Report: TAB Report
Function: Test, Adjust, & Balance
Date: 07/03/2024

06-24-24 WAWA #5413 SARASOTA, FL

Project: 06-24-24 WAWA #5413 SARASOTA, FL

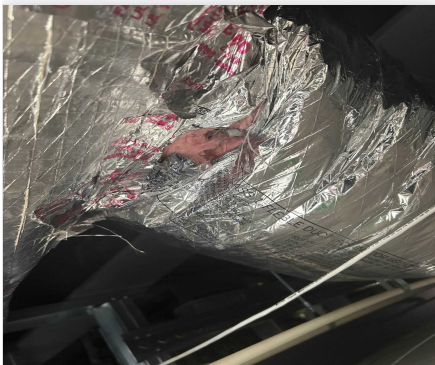
Issue Name : Diffuser 2-1 - damper missing wing nut
Description : Diffuser 2-1 currently has an airflow of 677 CFM (135% of design) and cannot be lowered because the damper will not hold the required position; it is missing a wing nut opposite the handle. Recommend repairing damper to allow for airflow adjustment.

- **06/30/2024 National TAB - Mark Johnson**
 - Mechanical clarified that damper design does not require second wing nut, and tightened handle to allow for adjustment. Could not re-adjust on site under time constraint.

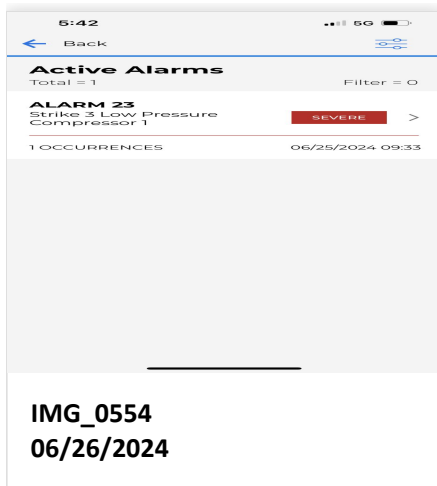
Issue Name : EF-2 low flow
Description : EF-2 is experiencing low exhaust flow (22 CFM, 37% of design) after installation of speed controller. Additionally, the fan is starting and stopping at frequent intervals. Fan is set to max speed. Recommend checking speed controller and wiring for possible faults.
